Attachment 1 - PLN19/0483 - 25-43 Wangaratta Street Richmond - Site Plan

Attachment 2 - PLN19/0483 - 25-43 Wangaratta Street Richmond - S52 Advertised Plans

25-43 WANGARATTA ST, RICHMOND, VIC, 3121
TOWN PLANNING SUBMISSION

Attachment 4 - PLN19/0483 - 25-43 Wangaratta Street Richmond - S55 Head, Transport for Victoria referral response

Ground floor interface

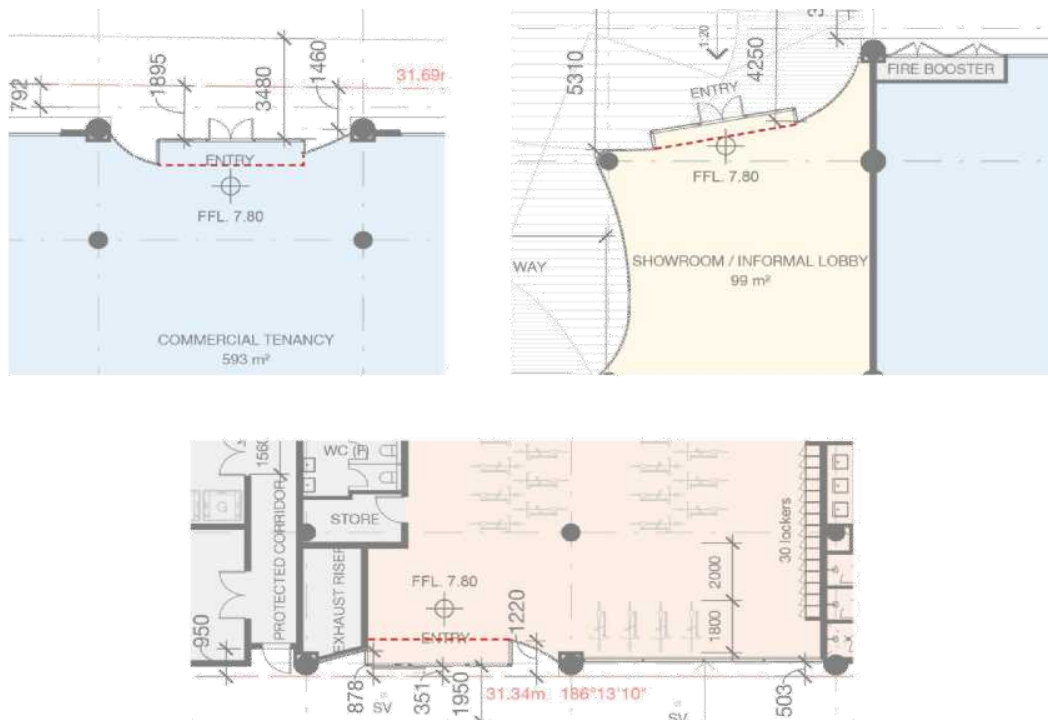
The overall materiality and composition of the façade is supported. It provides a good level of activation, transparency, articulation, and the pedestrian entries are well defined. However, the position of the building entrances within the façade creates a number of awkward corners adjacent the entries, which are likely to create litter traps. If possible, it is recommended that these entrances are further recessed into the building to avoid these corners. See diagram below:

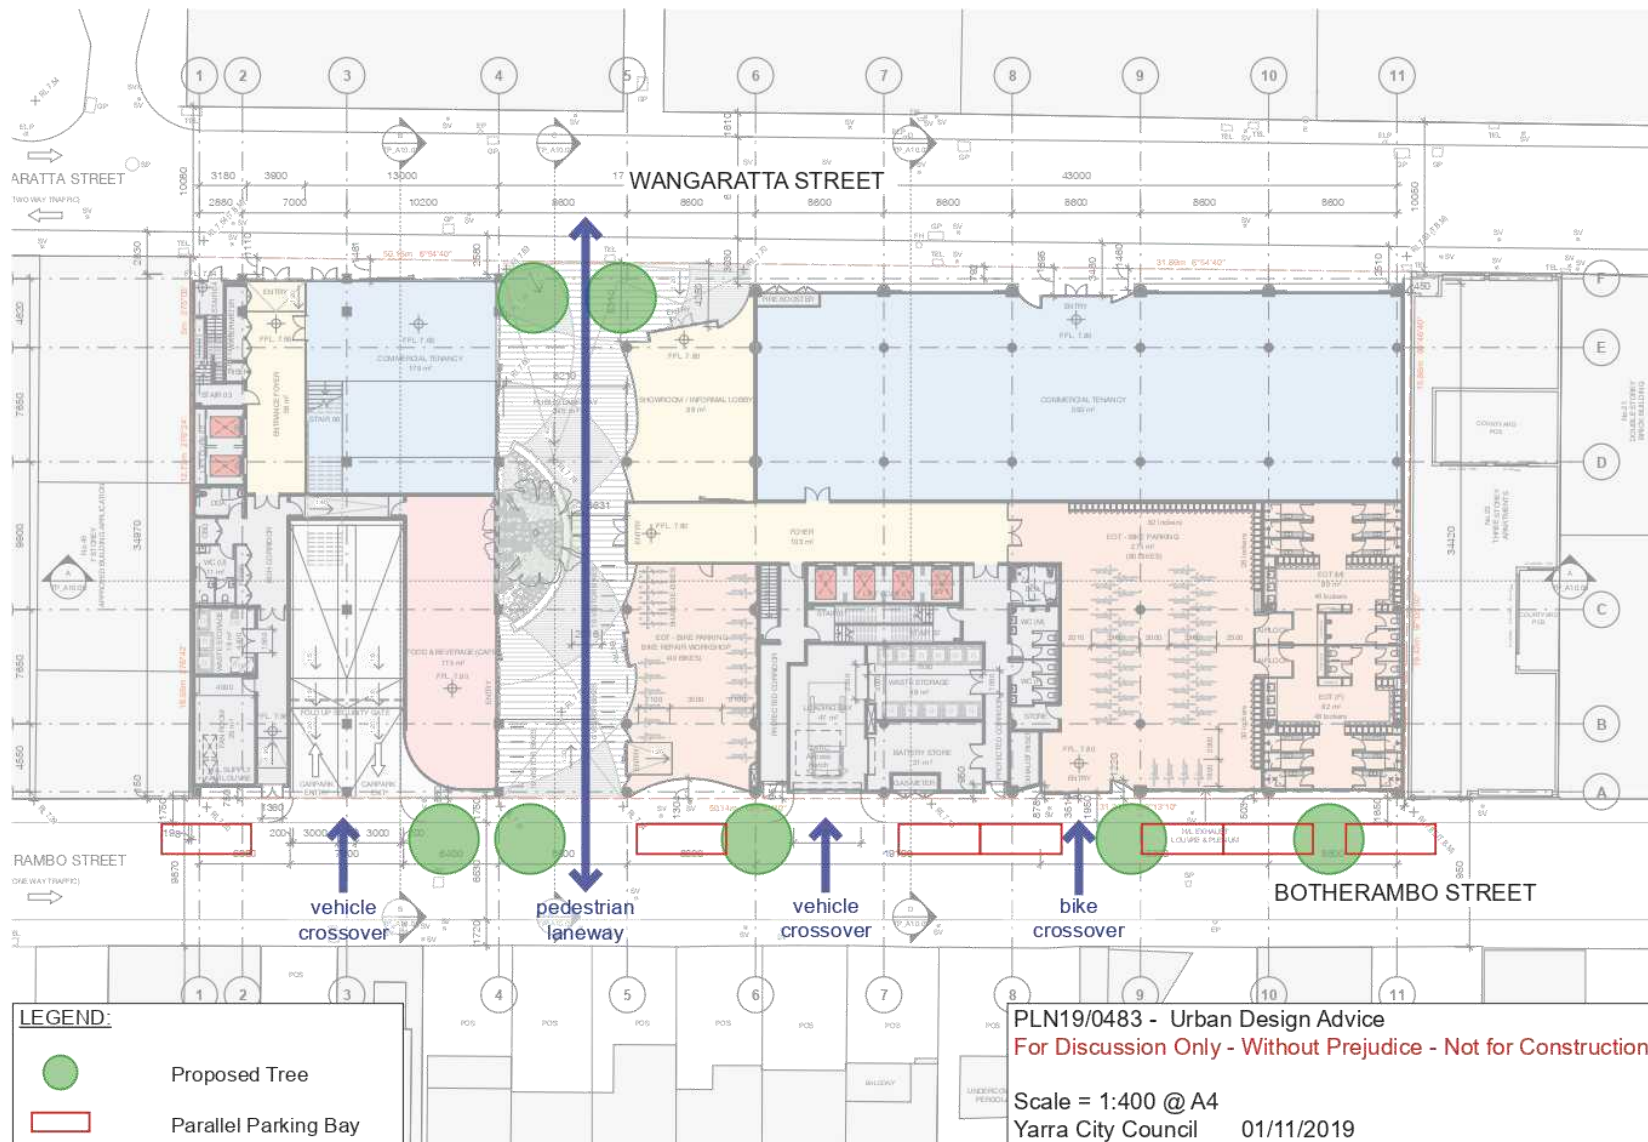
Street tree planting on Wangaratta Street is limited due to the narrow carriageway and footpath. To help enhance the pedestrian amenity of the street, it is recommended that the applicant provide additional tree planting within the subject site, at the western end of the proposed laneway link. This will help define the entrance to the laneway, as well as provide additional greenery to Wangaratta Street. Refer to attached mark-up.

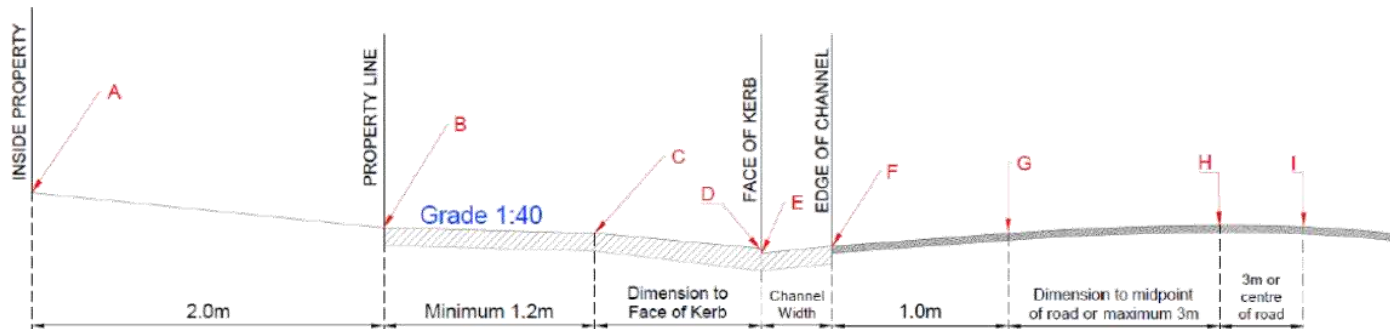
- o Please note the cross section must be fully dimensioned. As shown in the sketch below.
- o Please show both the existing and proposed surface.
- o The maximum allowable cross-fall between points B and C is 1:40 (2.5%).
- o A bullnose (max 60mm) is permitted at point D, however not compulsory.
- o The levels shown must be exact reduced levels, to three decimal points. Interpolation of levels is not acceptable.
- o The designer must demonstrate that an 85th or 99th percentile vehicle profile can traverse the design cross section as per the Australian/New Zealand Standard ground clearance template (AS/NZS 2890.1:2004).
- o Significant level changes to the existing footpath level B to C will require additional level design either side of the proposed crossing.
- o Please include any additional levels or changes in grade that are not shown in the diagram.

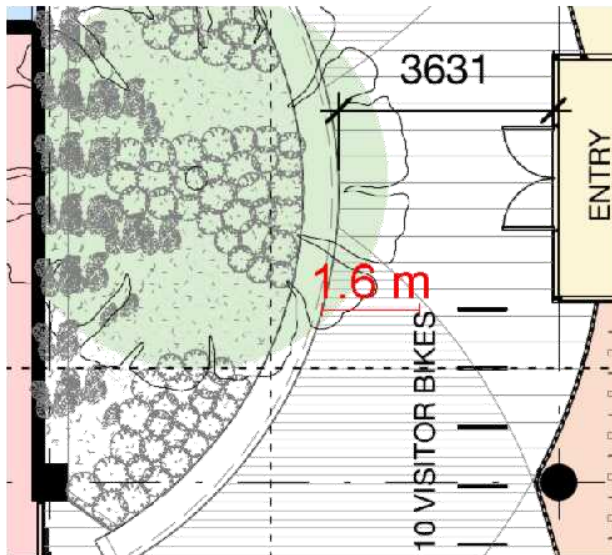
It is noted that the the 10 visitor bike spaces located adjacent to the central entry (pictured below) could impede pedestrian circulation through the public laneway and adjacent entry when bikes are parked at the hoops. Therefore it is recommended that these 5 visitor hoops are relocated to the Wangaratta Street entrance of the public laneway to provide a wider accessway at this section of the laneway and to also provide visitor bike parking at the Wangaratta Street entrance to the site.

Upper level setback recommendations to Wangaratta St & Botherambo St for the southern building.

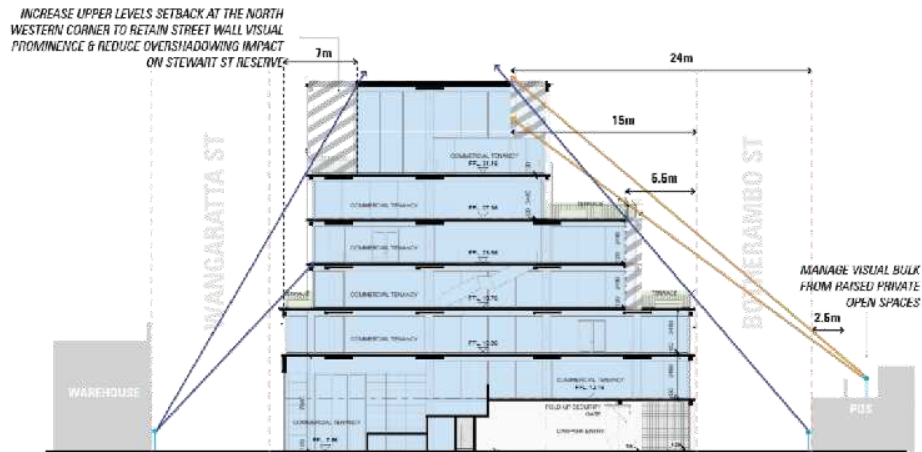
- Whilst we are generally supportive of the 'grouping' of upper level setbacks to avoid an overtly stepped building profile, an increase upper level setbacks to 5.5m for levels 3 and 4 and a setback to 15m for the uppermost level (level 7) is required to ensure levels above level 4 are not readily visible from Botherambo Street. Furthermore, an increase to upper level setbacks will also reduce the visual exposure of upper levels from private open space (particularly roof top open spaces).

Upper level setback recommendations to Botherambo St for the northern building.

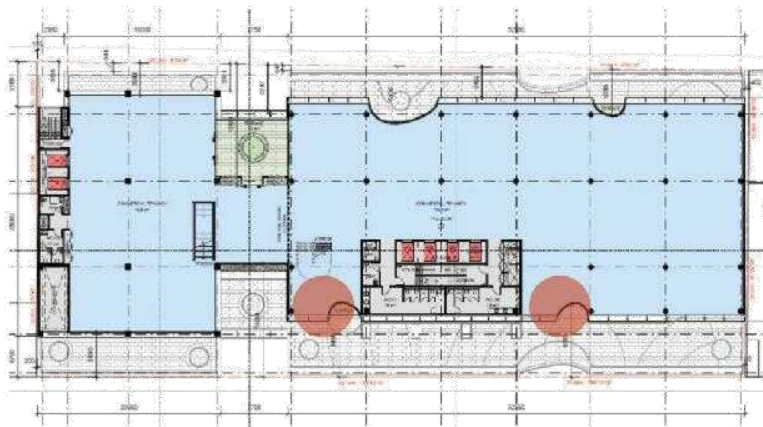
Larger sculpted terraces for Northern Building at 3rd, 4th and 5th levels address visual bulk along Botherambo Street

Figure 1: Public Laneway Detail Plan

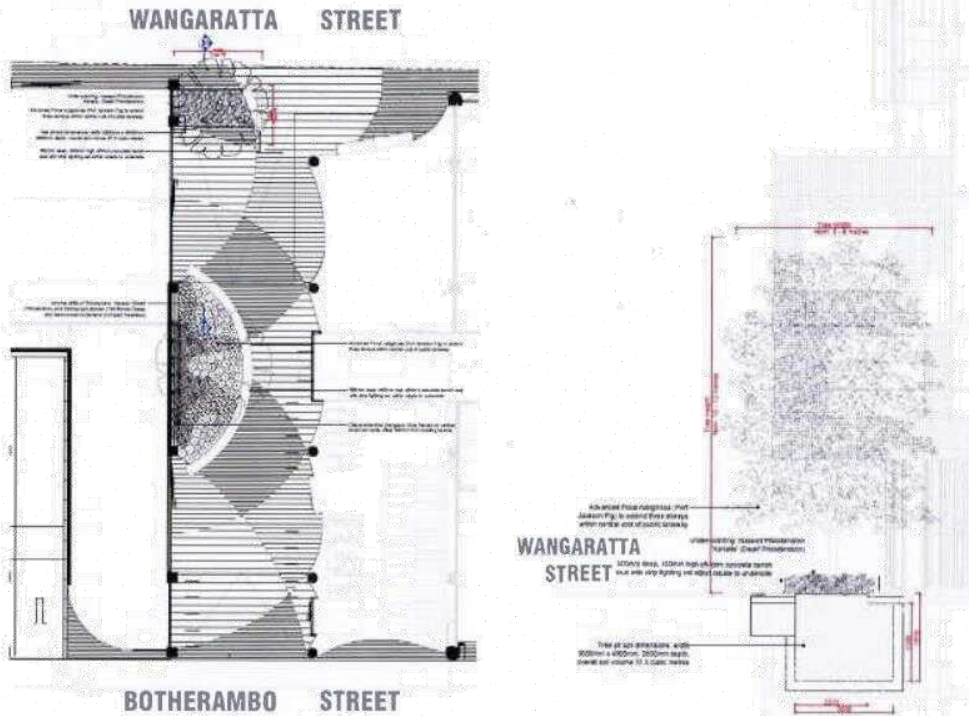
- A large tree to extend three storeys within the central void of the public laneway (Figure 1), or
- The same large three storey tree but with a 450 mm high public seating element.
